RESIDENCES AT ALEWIFE STATION

195 & 211 CONCORD TURNPIKE
SUPPLEMENT TO SPECIAL PERMIT APPLICATION

03/21/2017

FIG. 16.2

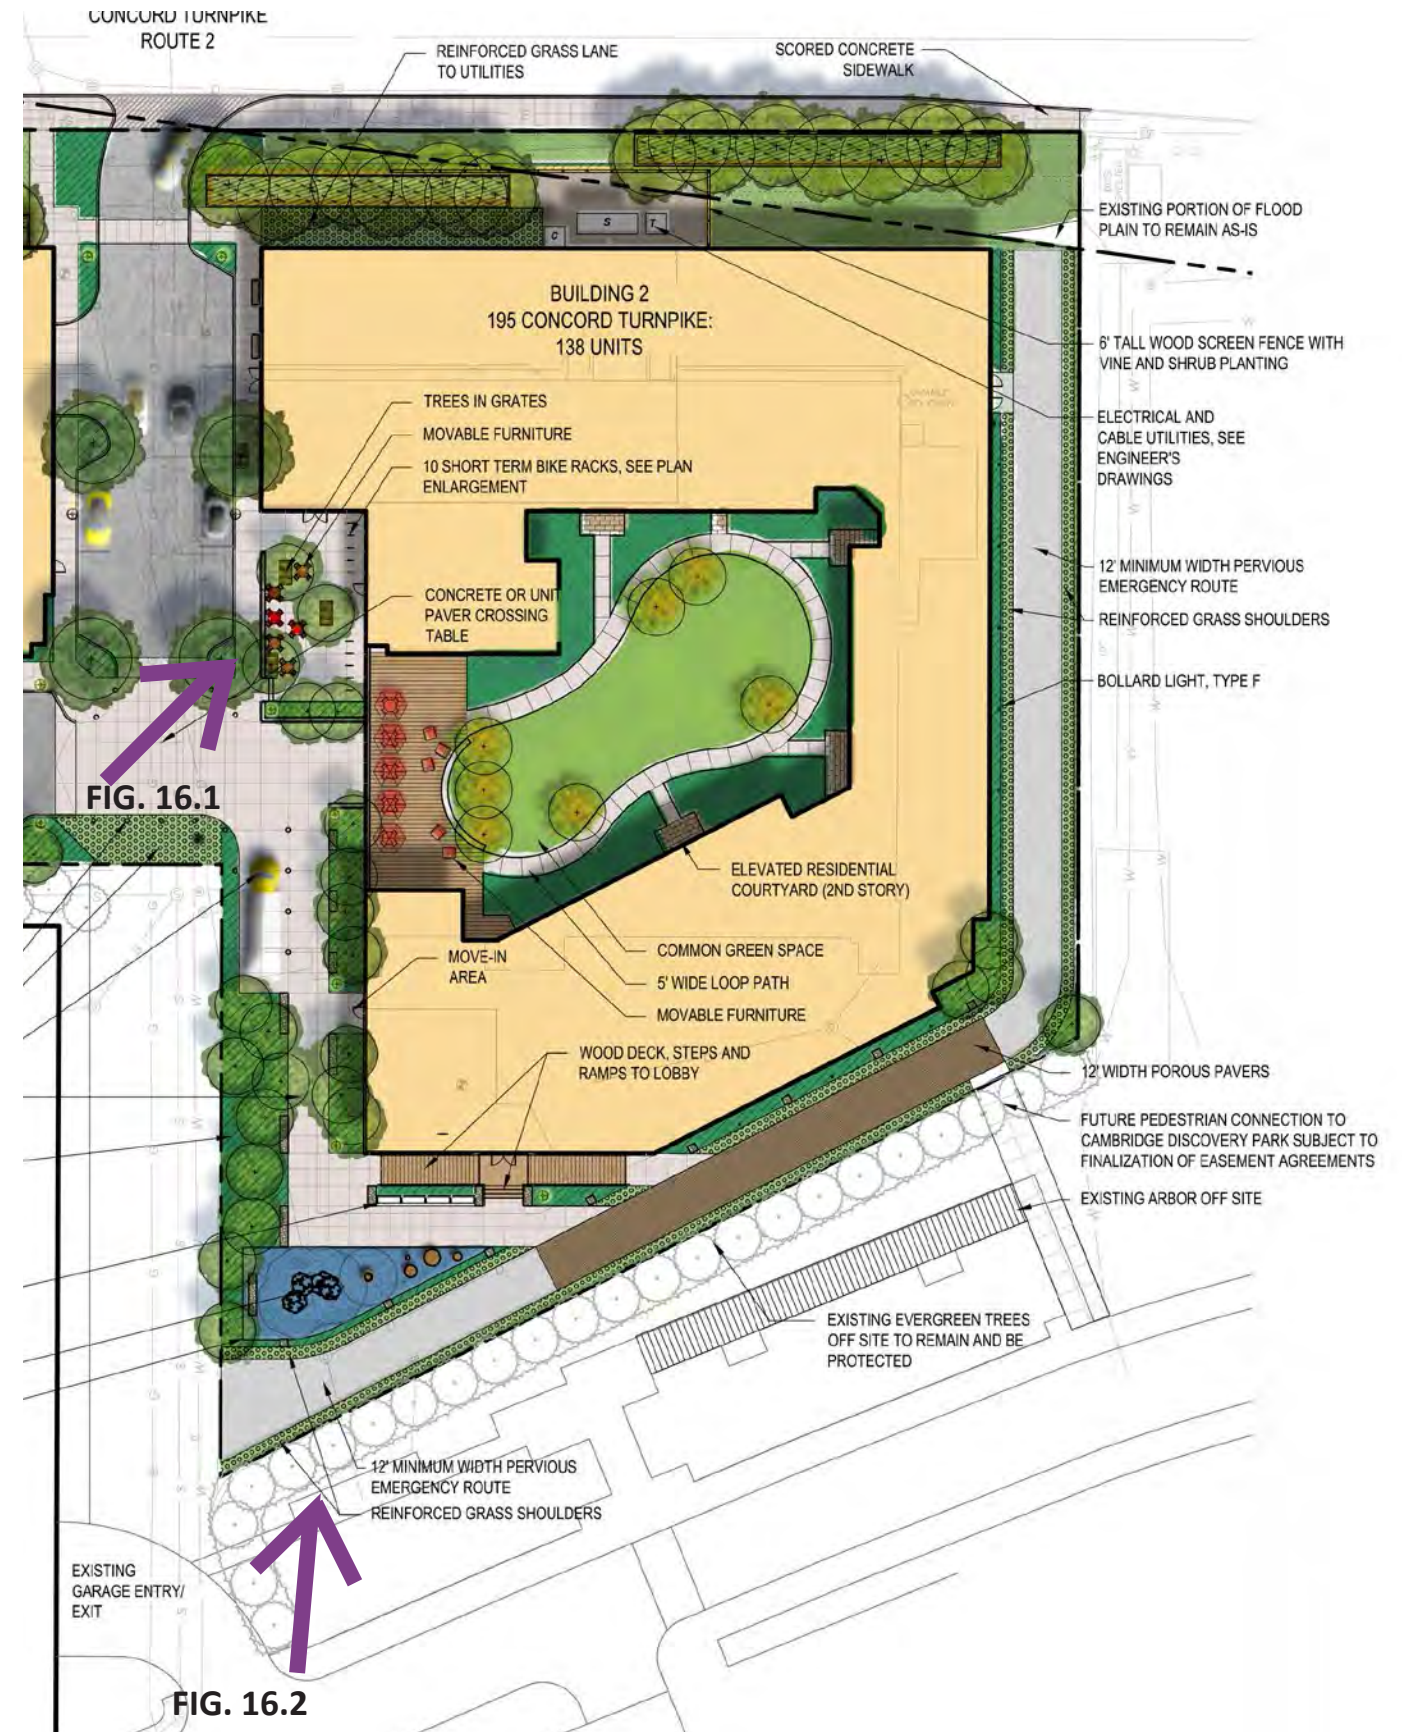
How can we add more open space and programmable areas into the site and along pedestrian walkways? Can we move the buildings closer to Route 2 and relocate the open space along Route 2 into the site?

We cannot push Building 1 closer to Route 2 as we are purposely creating an offset from the Vox building face to eliminate the feel of a straight wall of buildings. Additionally, the rain garden between Building 1 and Route 2 is a critical element of the Site's resiliency design. It serves as a drainage element and compensatory flood storage area and cannot be relocated internal to the site based on grading requirements. However, without moving the buildings closer to Route 2, we have made numerous changes to the proposed site design that achieve the goal of increasing open space on the Site.

- The Patio outside of the Building 2/Route 2 lobby has been expanded – by shifting the drive entry to the garage, we have lengthened this southern facing patio area, providing more trees and places to sit and meet.

- The roadway intersection has been designed as a raised crossing, with specialty paving – allowing residents moving thru this area to cross on a diagonal, if desired. The raised table will slow cars turning through this area.

- A broad, tree-lined walkway has been incorporated, extending from the Building 2/Route 2 Lobby all the way back to Discovery Park. Building 2 was redesigned / “trimmed” to set back on its southwest corner. This has allowed a wider walkway focused on a children’s play area at its southern terminus, with an iconic, sculptural play structure focusing one’s view.

FIG. 18.1
Typical Building Materials

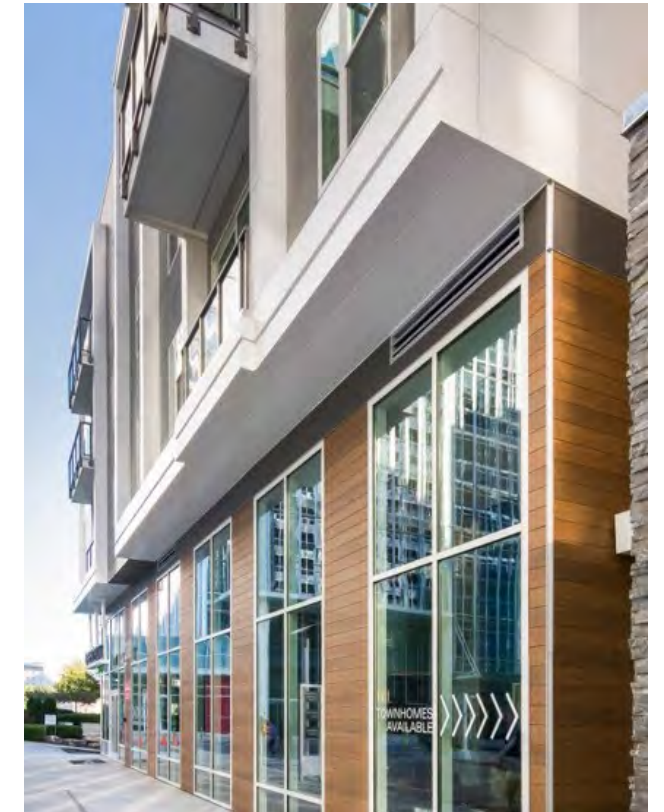
What are the building materials and how will they hold up over time?

The buildings will be constructed using a post tensioned concrete podium at the ground floor/garage level and 5 stories of fire treated wood framing above. The concrete podium lends itself to construction within a flood zone due to its flood resiliency.

The buildings will be clad with high quality residential scaled materials. All exterior walls will be constructed of non-combustible materials. Facades will consist of fiber cement siding, panels and trim with a class A fire rating, superior durability and a 50 year warranty

Windows will be energy efficient double glazed casements . Triple glazed windows will be used on the Route 2 elevation facing Route 2 for sound reduction.
